Final Environmental Impact Statement

Malone Solar Project

Franklin County, New York

3. RESPONSE TO COMMENTS..... 15

C009

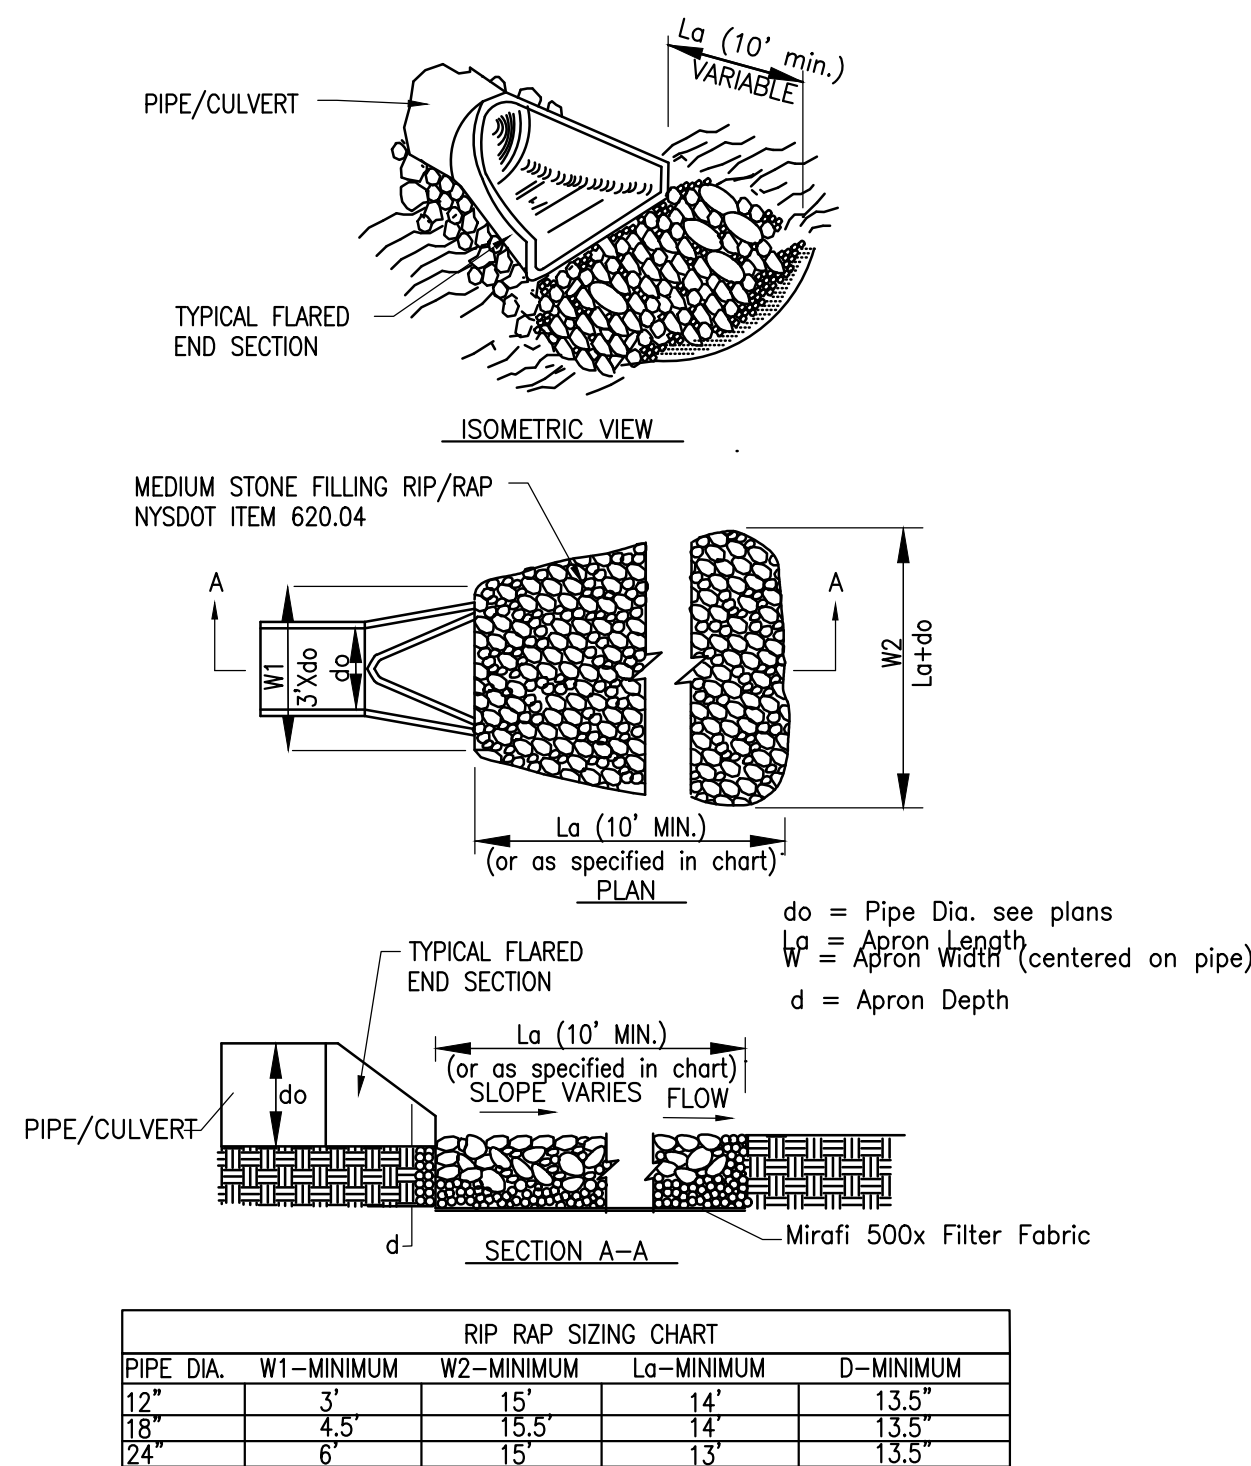
Comment 10: “The DEIS Attachment B glint and glare analysis was conducted at an array height of 4.5 feet above the ground. The provided Drawing Number C009 shows a racking height at 4.5 minimum, but the November 2022 analysis used 6.5 feet. Please explain why the height changed.”

Response 10: *The height changed due to an older layout design change. Further, as noted in this FEIS, the Project layout changed again since acceptance of the DEIS, and this centroid height changed to 5.1 feet based on the updated panel layout. This updated centroid height of 5.1 feet was included in the updated glare analysis (**Attachment I**).*
